**TABLE OF CHANGES FOR PLANNING
AMMENDMENTS: SECTIONS & ELEVATIONS**

T2 VITA LIVING, ST. JOHNS

PROPOSED CONTEXTUAL
NORTH ELEVATION

6555-P-B500-E-N-001

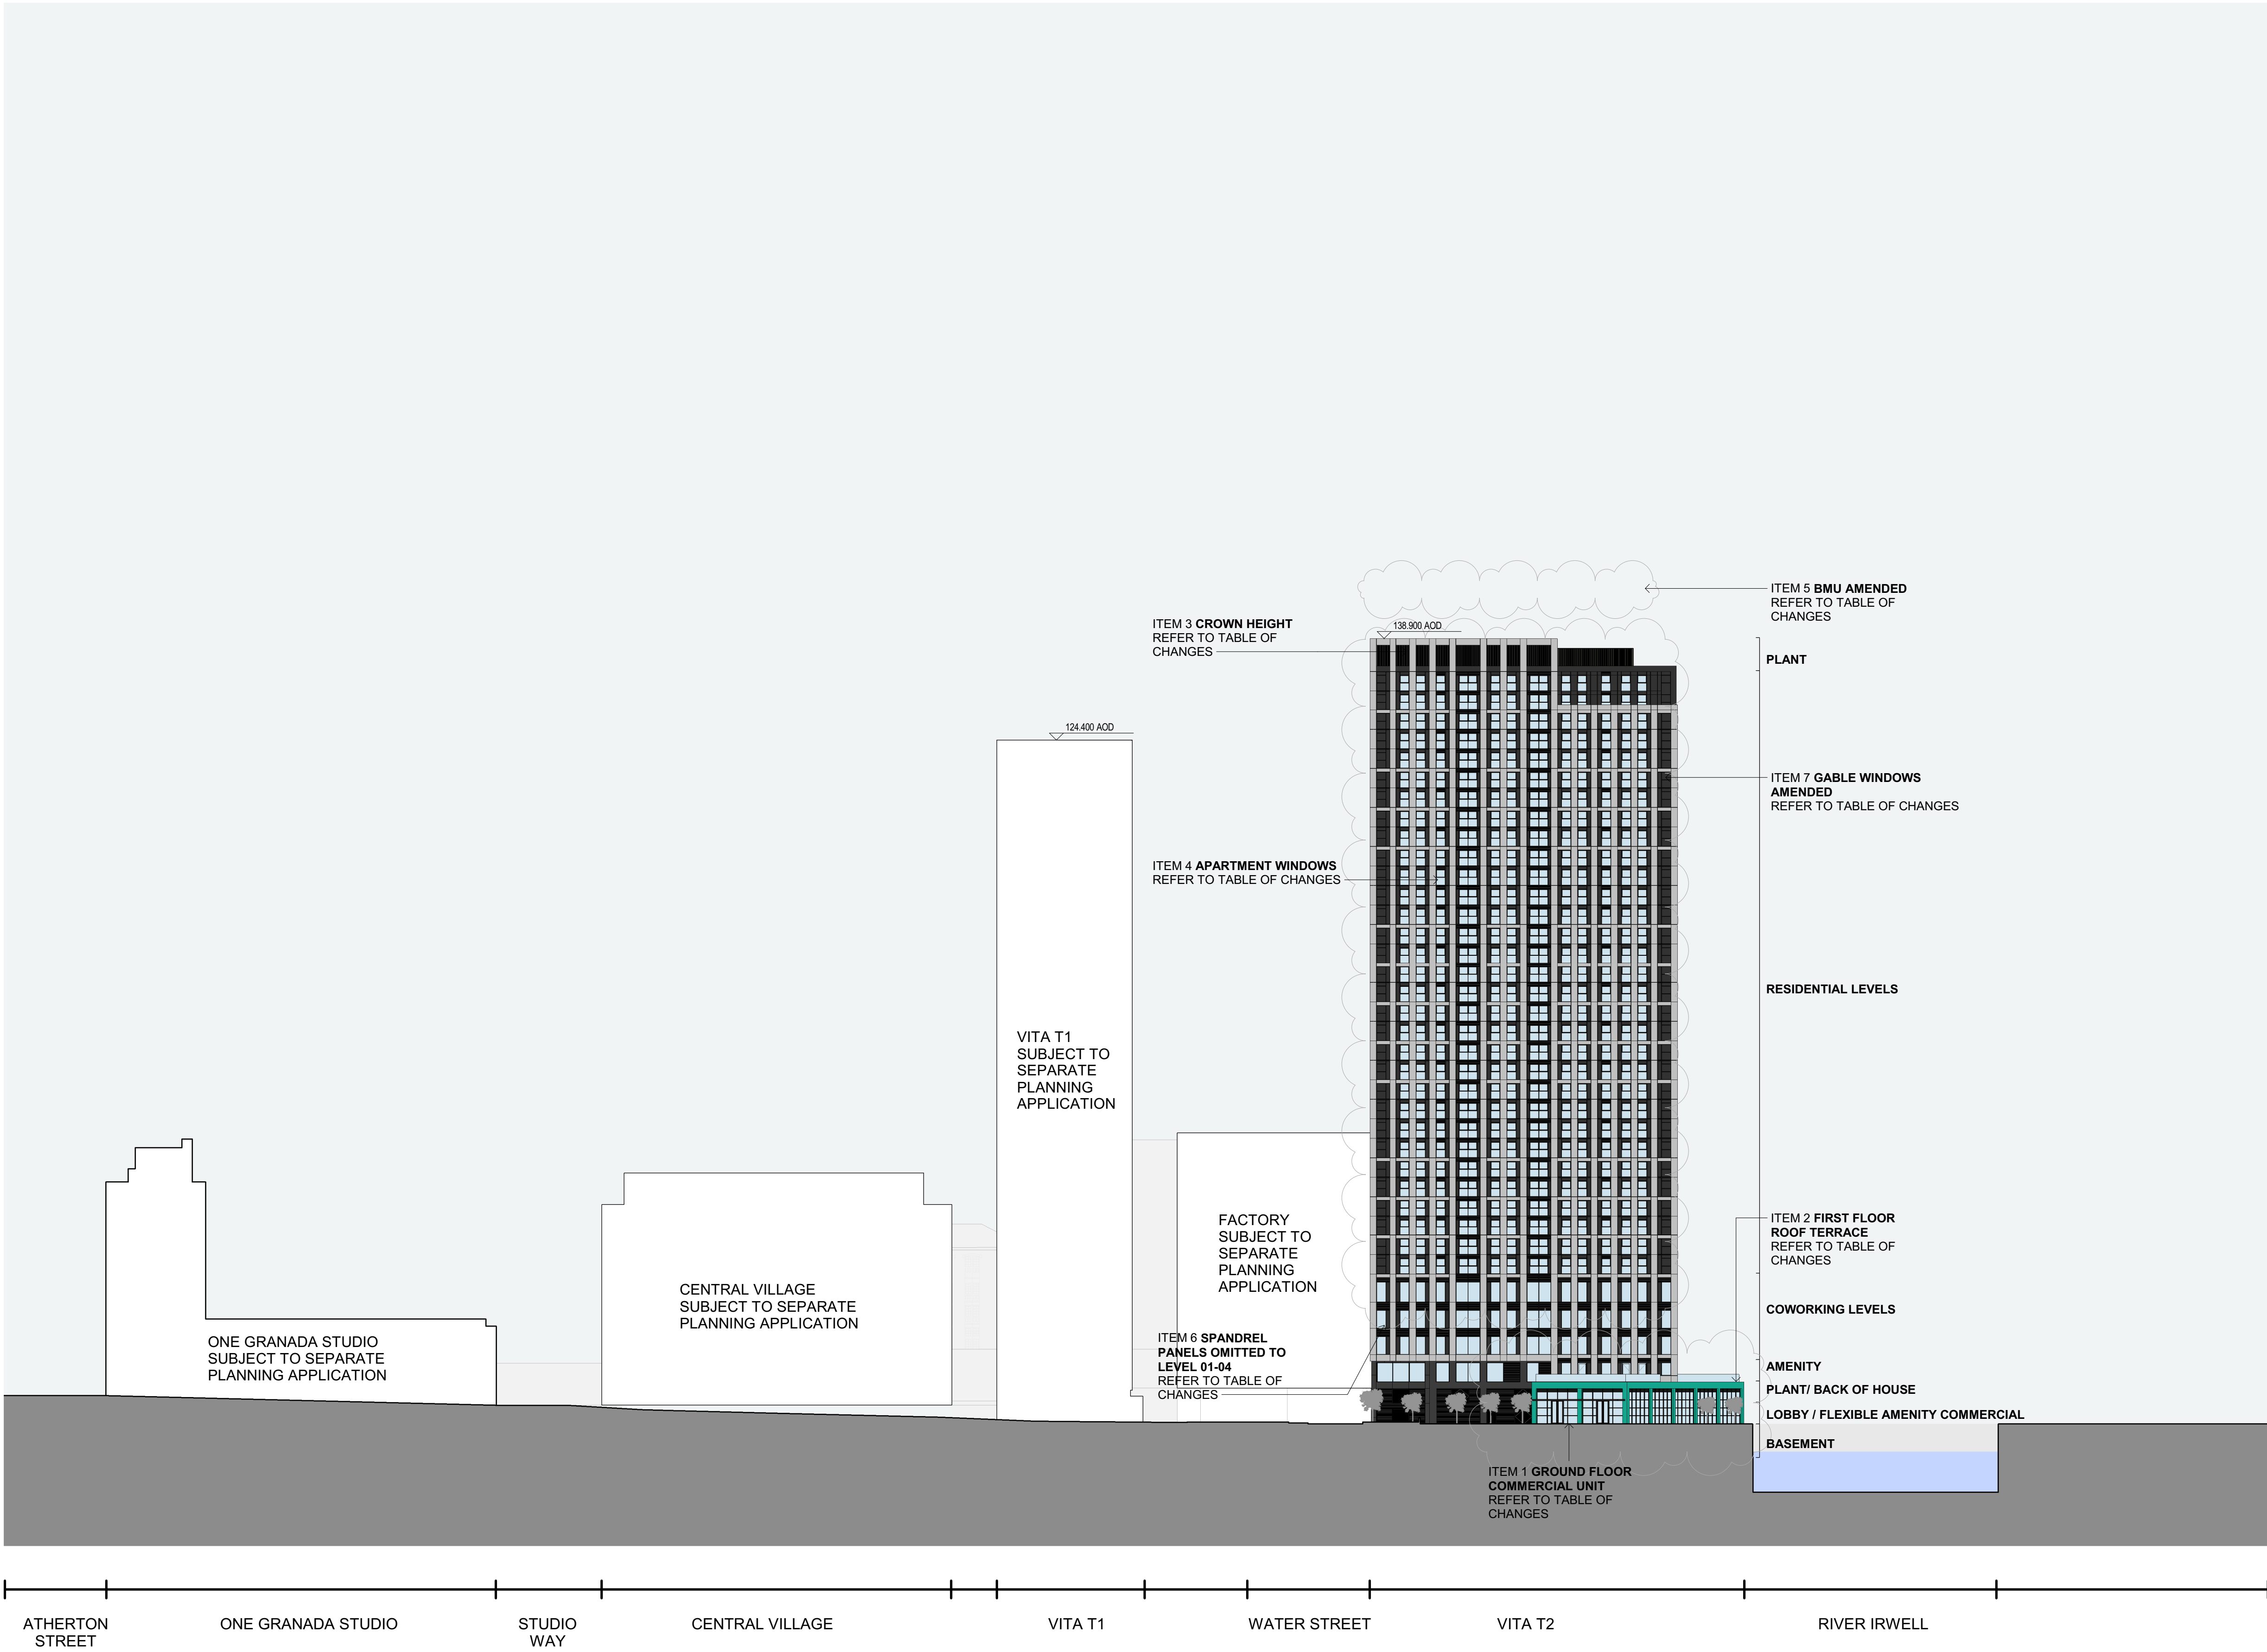
- 1 - GROUND FLOOR COMMERCIAL UNIT**
GROUND FLOOR FOOTPRINT DEVELOPED TO INCLUDE
COMMERCIAL UNIT
- 2 - ROOF TERRACE**
INTRODUCED AT LEVEL 01 WITH GLAZED
PERIMETER BALUSTRADE

- 3 - CROWN HEIGHT**
HEIGHT OF CROWN REDUCED BY 1.31M
OVERALL BUILDING HEIGHT REDUCED TO 112M
- 4 - APARTMENT WINDOWS**
SIZE / CONFIGURATION OF APARTMENT WINDOWS
TO RESIDENTIAL FLOORS AMENDED

- 5 - BMU AMENDED**
STATIC ROOF-MOUNTED MAINTENANCE UNIT (BMU)
AMENDED TO MOBILE PERIMETER TRACK-MOUNTED
TYPE BMU WHICH WHEN PARKED IS FULLY
CONCEALED
- 6 - SPANDREL PANELS OMITTED AT LEVEL 01-04**
FIXED GLAZED SPANDREL PANELS TO BOTTOM OF
LEVEL 01-04 GLAZED SCREENS OMITTED TO NOW MAKE
THE SCREENS FULL HEIGHT

- 7 - GABLE FACADE AMENDED**
SIZE AND CONFIGURATION OF WINDOWS FIXED CLEAR
GLAZING AND METAL FACADE PANELS AMENDED TO
ALIGN WITH SPECIALIST DESIGN ADVICE
- 8 - WIND MITIGATION STRATEGY**
ADDITIONAL TREES, CANOPY, WALKWAY ARCHES,
BALUSTRADES AND SCREENS INTRODUCED FOLLOWING
WIND MITIGATION ANALYSIS
